From: Mitman, Jeffrey *NR*
Sent: Monday, December 20, 2010 2:41 PM
To: Ferrante, Fernando *NR*
Subject: FW: Spillway Curve
Attachments: Hydralogy - N values and Spillway Curves.pdf

Fernando, I'm not sure where I got the attached document. It appears to be an early evaluation by hydrologist in regard to the inundation analysis. My reason for sending it to you is the information on the JD spillways.

Evaluation of Curve Number

Spillway Discharge Curve

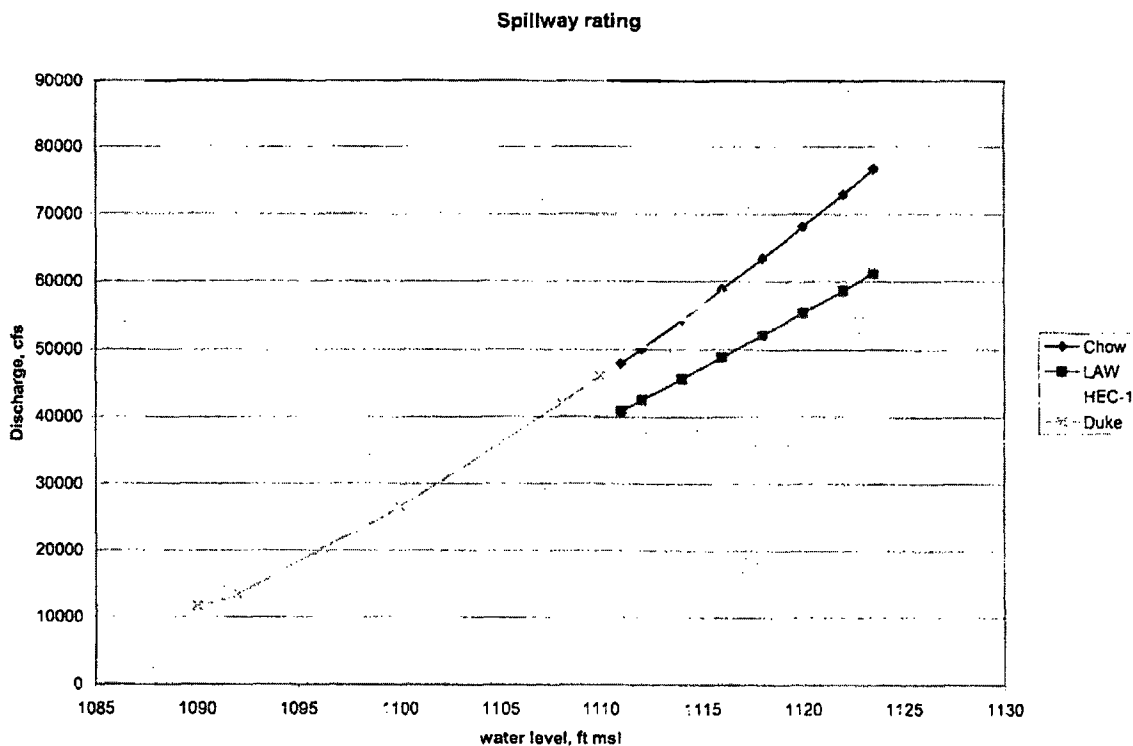
The spillway discharge curve as used in the LAW Engineering analysis could not be confirmed in this evaluation. The staff did calculate a spillway rating curve using information developed by the U.S Army Waterways Experiment Station and presented in Section 14.7 of Open Channel Hydraulics (Chow, 1959). In this method, piers in gated spillways are adjusted for using the relationship $L = L_0 - K N H_e$ where:

With the spillway coefficient of discharge equal to 4.0, $Q = 120 H_e^{1.5}$ for each bay of the spillway. This relationship corresponds approximately to the discharge curve by Duke used by FEI in the FERC report (2004) presented in this report. The discharge determined in the original study evaluated by AEC approximates the value that would be determined from this relationship (72,000 cfs as compared to 73,660 cfs).

The staff also considered the methodology presented in the HEC-1 program manual. Using this methodology, a different shaped curve was determined. Also, the original rating curve ended at

el 1123.5 because the low chord of the bridge is at this elevation and flow out of the reservoir changes to orifice flow at this level. Because of the higher water levels to be evaluated, the rating curve was adjusted for orifice flow and added to the program. All three rating curves are shown in Figure ____.
